**SECTION 01 30 01**  
**REQUEST FOR INTERPRETATION FORM**  
**CONSENTINO MIDDLE SCHOOL - #21-0818**

<b>TO:</b> Dore & Whittier Architects Inc. 260 Merrimac St., Bldg.7 Newburyport, MA 01950	<b>FROM:</b>  Brait Builders	<b>RFI #:</b>  RFI - 038
<b>Attn:</b> Tara King	<b>Reply Requested by:</b> Jake McDonough	<b>Issue Date:</b> 05/24/24
<b>RFI DESCRIPTION</b> (Indicate origin of RFI, and summarize the question or type of information required):  Please see attached drainage clocks with constructibility issues. Please advise how to proceed.		
<b>REFERENCES</b> (List relevant Drawings or Specification sections and paragraphs):  		
<b>SENDER'S RECOMMENDATION</b> (All RFIs must include a contractor's recommended solution to each condition, including a statement of cost or schedule of impact if applicable. The contractor may be back-charged by the Owner for designer's review time for any RFI submitted without a sender's recommended solution or where response is evident in Drawings.)  Nitsch Comment: Refer to comments below and ASI-11 for updates.

# REQUEST FOR INFORMATION

# PROPOSAL REQUEST

Structure: CB 118  
Based On:  
Job Name: CONSENTINO MIDDLE SCHOOL  
Job Location:  
Specification: 48" Storm  
Contractor: DERENZO

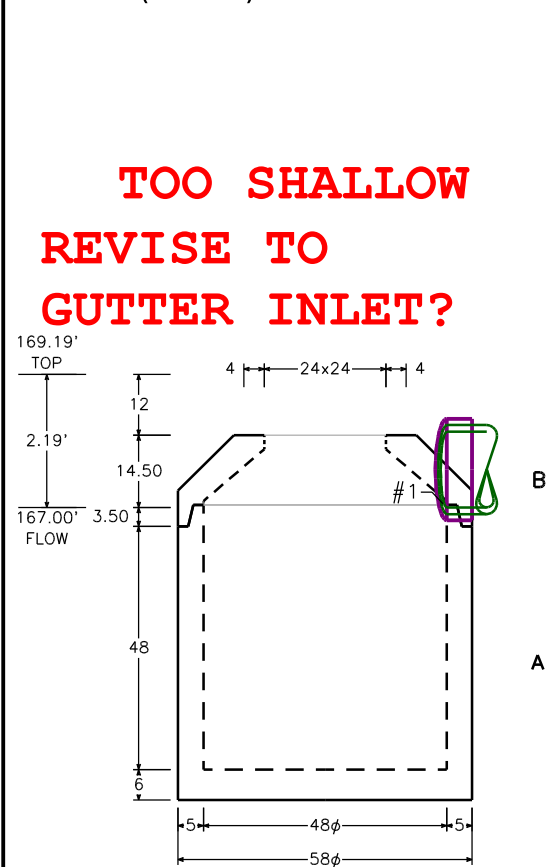
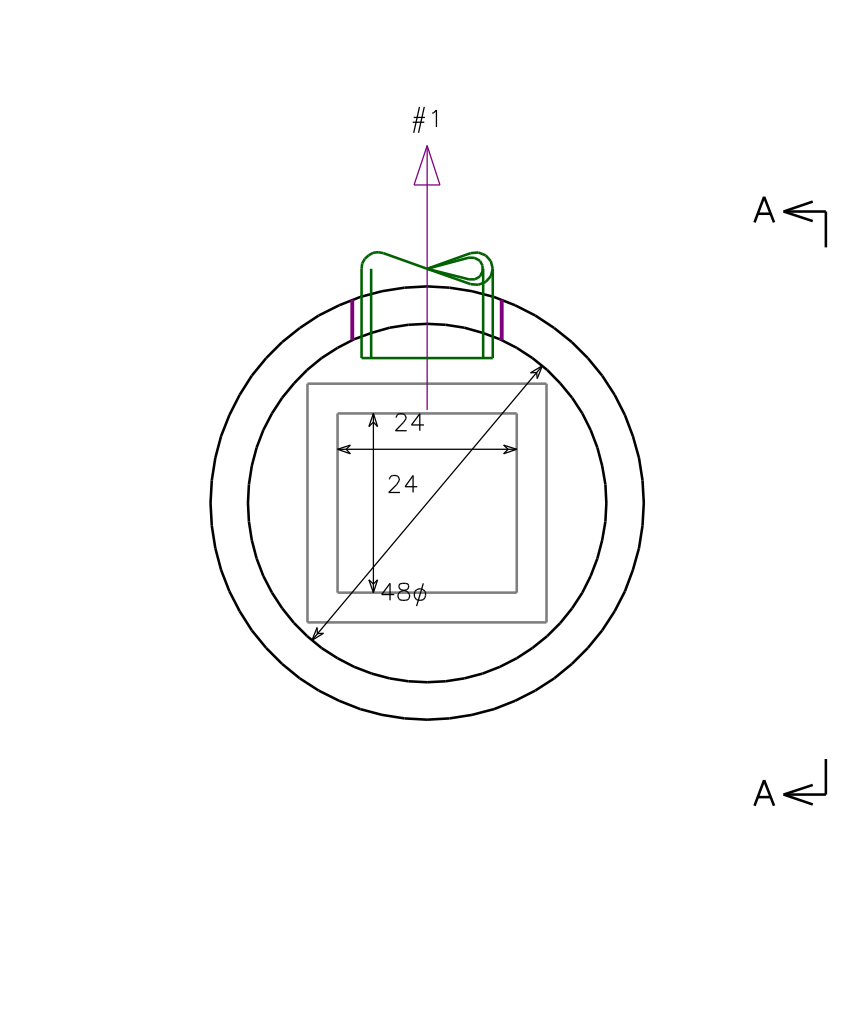
Please see attached drainage clocks with constructibility issues. Please advise how to proceed.

Nitsch Response:  
Outlet lowered to 166.52  
(assuming flat top structure)  
Refer to ASI-11 as this lowered  
some downstream inverts as well

Structure: D 202  
Based On:  
Job Name: CONSENTINO MIDDLE SCHOOL  
Job Location:  
Specification: 48" Storm  
Contractor: DERENZO

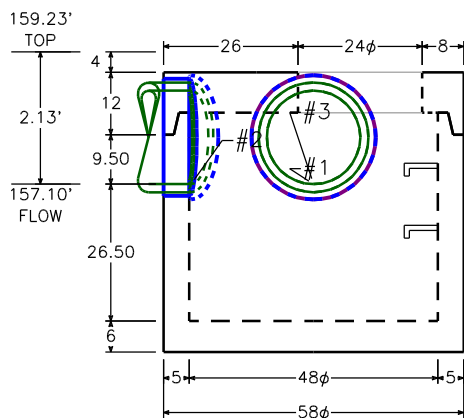
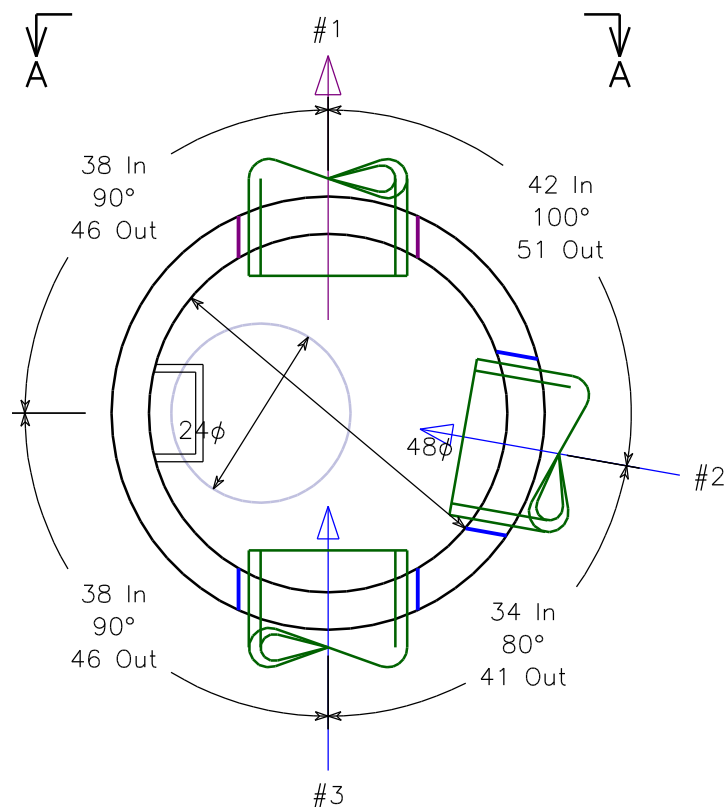
**TOO SHALLOW**  
**TEE**  
**CONNECTION TO**  
**MAIN?**

Nitsch Response: Revise  
rim to finish grade ~162.50  
(Refer to ASI-11)

Structure: D 226  
Based On:  
Job Name: CONSENTINO MIDDLE SCHOOL  
Job Location:  
Specification: 48" Storm  
Contractor: DERENZO

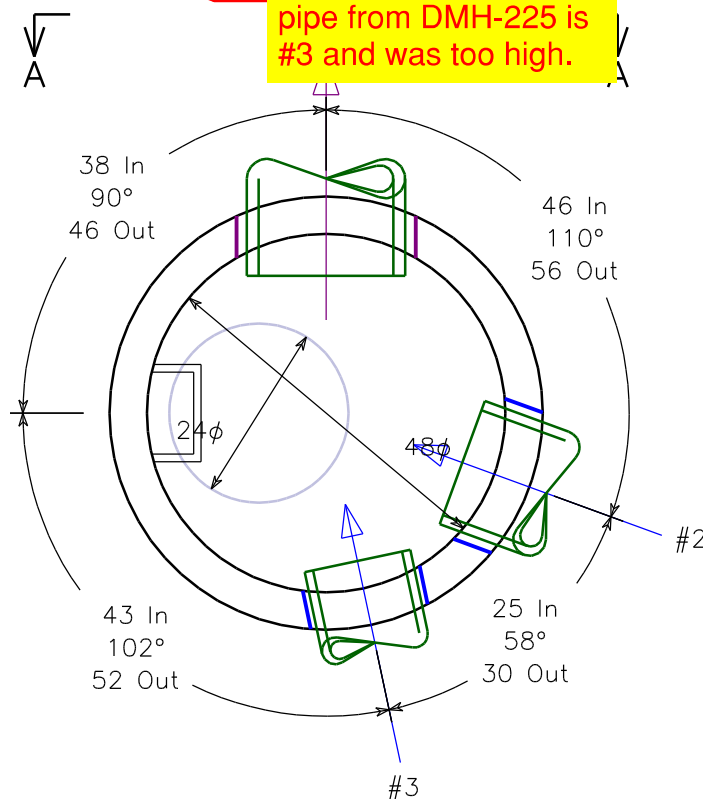
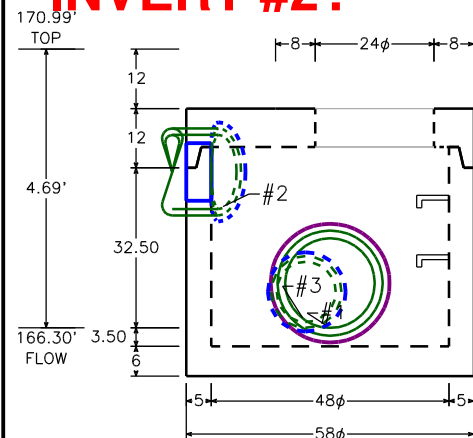
TOO SHALLOW  
LOWER  
INVERT #2?

Nitsch Response: Update  
Inverts per ASI-11

Structure: CB 118  
Based On:  
Job Name: CONSENTINO MIDDLE SCHOOL  
Job Location:  
Specification: 48" Storm  
Contractor: DERENZO

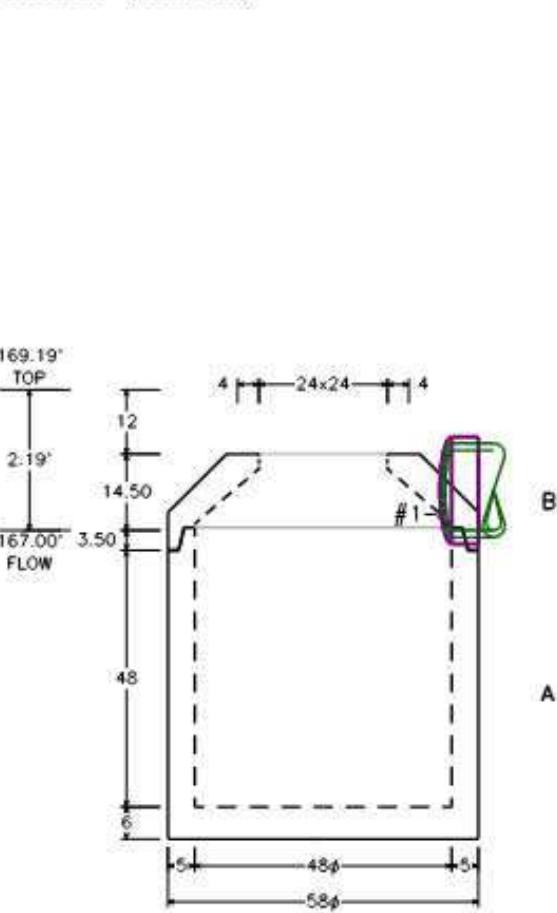
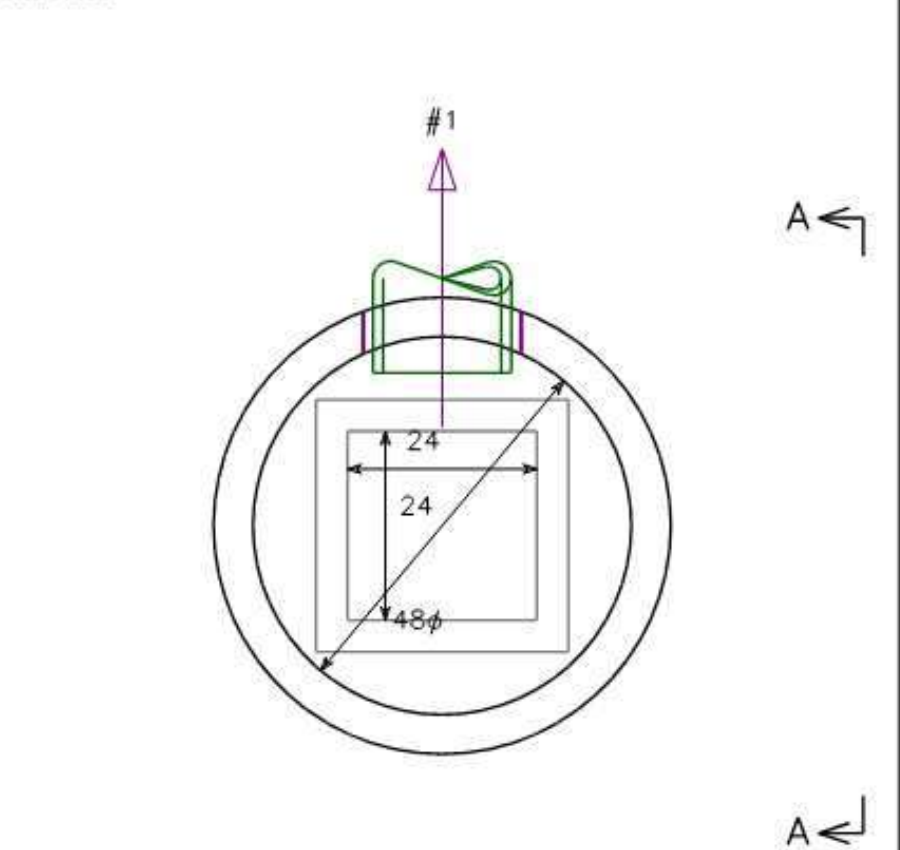
Pipe is 18" too shallow. Zero pitch to play with towards WQs-1 that it connects too. Please advise.

Nitsch Engineering - 2024-07-19 M. Valentino  
Please see the attached PR-04 which includes invert revisions.

JD-32

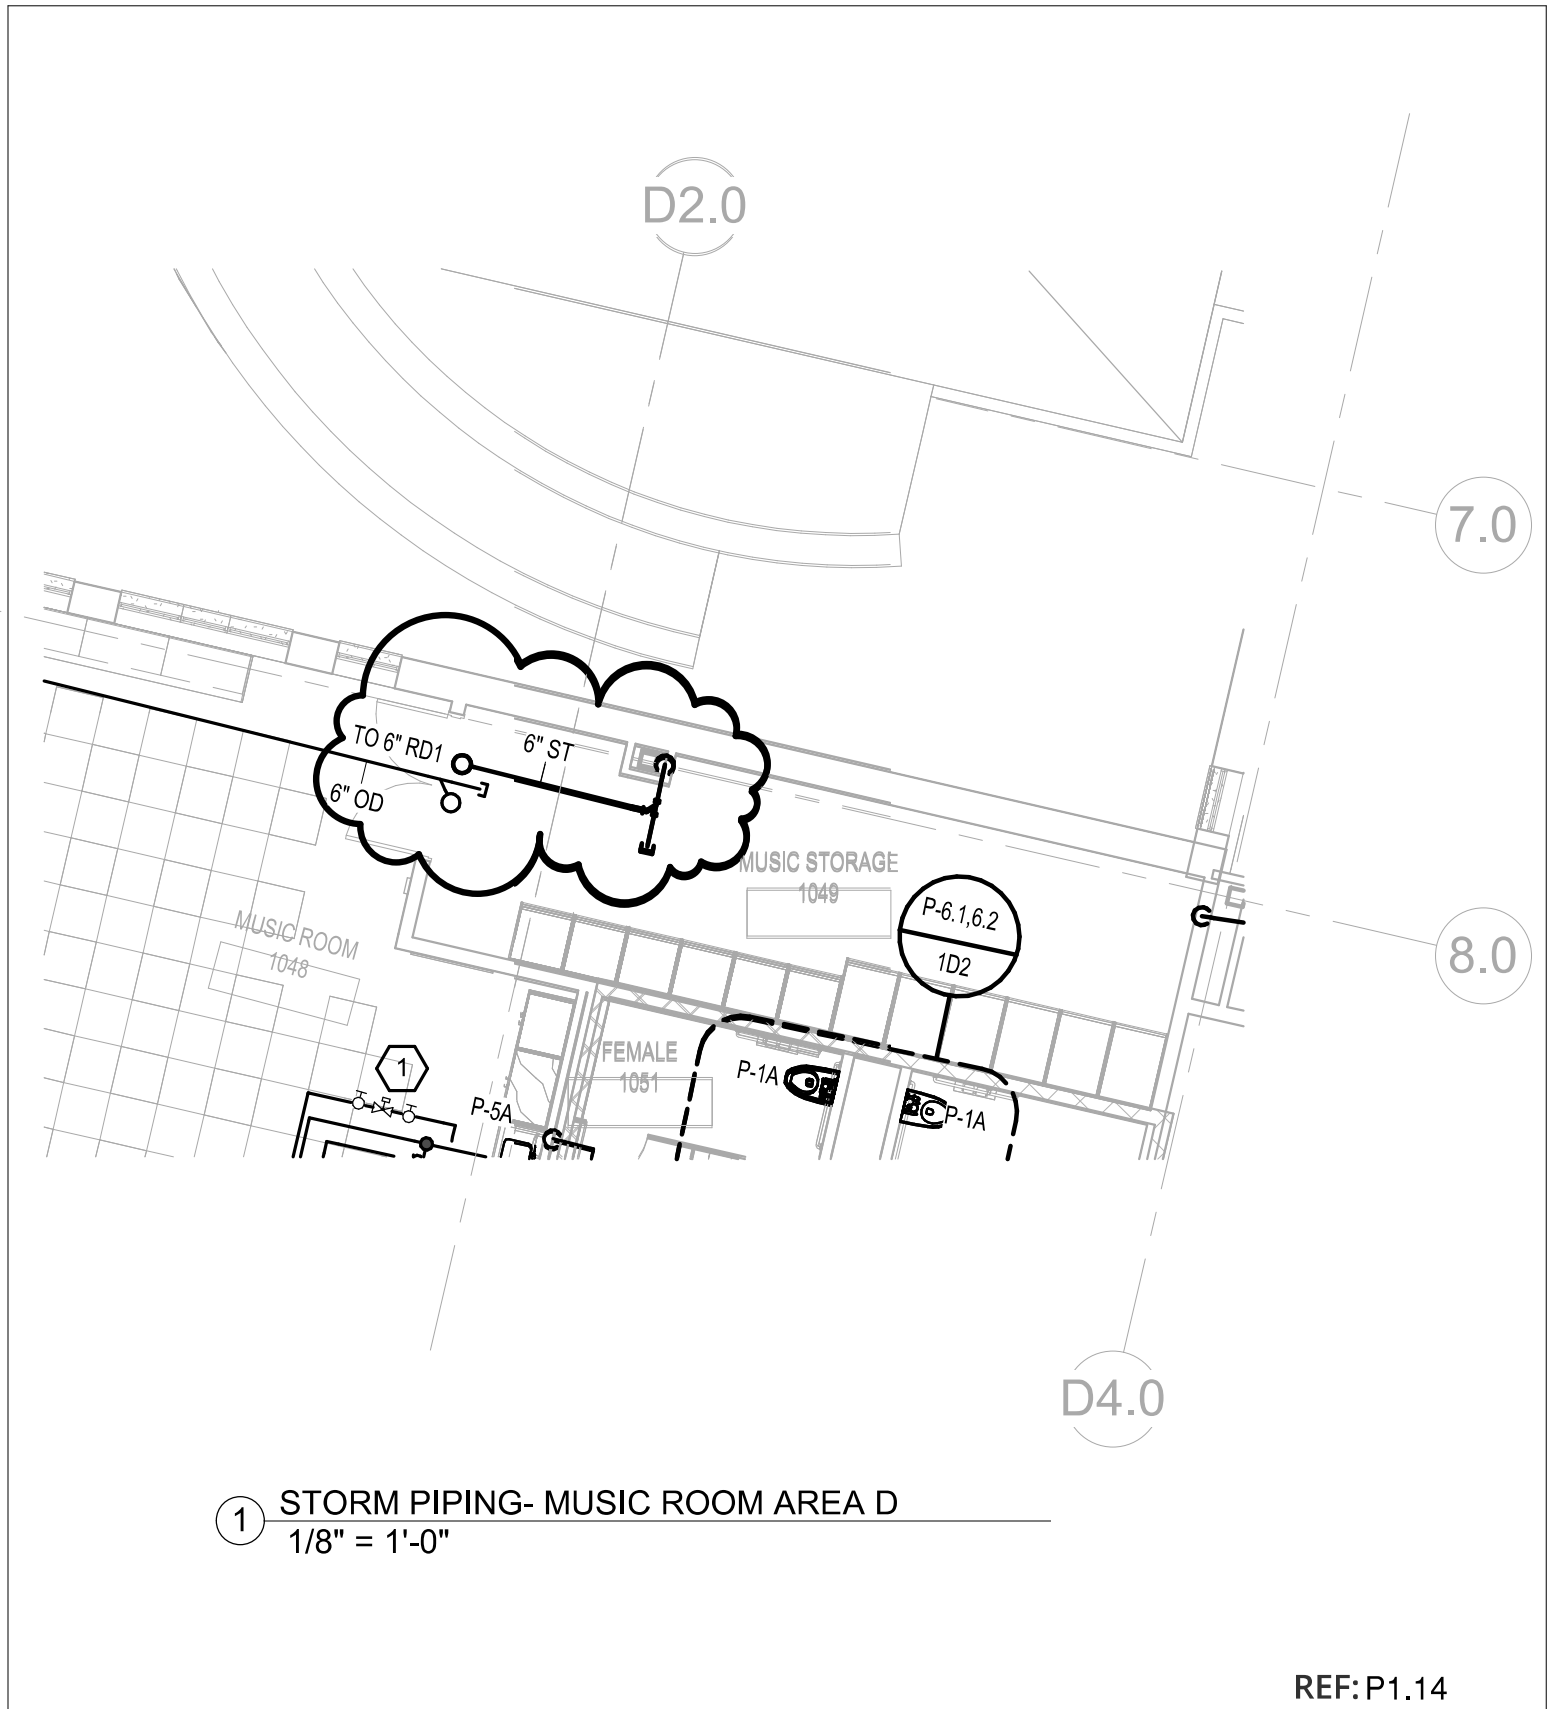
At Sheet P4.13 Plumbing Overall Roof Plan, delete 4" RD1 and associated piping from Gym storage to proposed drain, as shown on Sheet P1.14 at grid 17.0 (shown as grid 16.6 on Plumbing drawings) to match architectural roof plan A3.14. Refer to attached sketch **JD-32**. Make similar revision to P2.14.
